ADDENDUM 2: Skyline Engineering

JAMES LICK HIGH SCHOOL

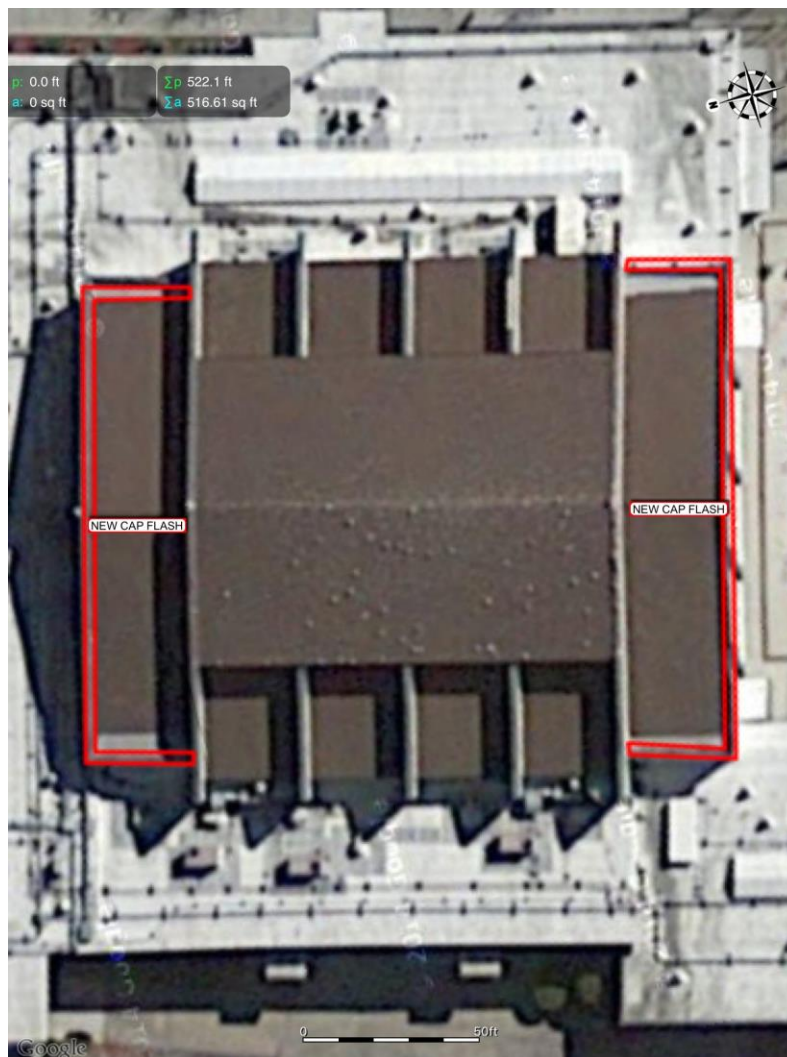
The long north and south sections of parapet wall outlined below were found to be concrete – not to have an existing metal CAP flashing. Provide a new metal CAP flashing that is continuous - covering all of the lower long shingle roof parapet walls. Install a wood nailer on top of these parapet walls as specified. Extend the single ply system - as specified for the low east and west valleys – to completely cover ALL parapet walls – up and over – prior to installing the CAP flashing. This single ply base flashing shall be fully adhered. The single ply base flashing shall extend a minimum of 18” under the specified shingle system.

Please note that ALL of the parapet walls shall receive new metal CAP flashing.
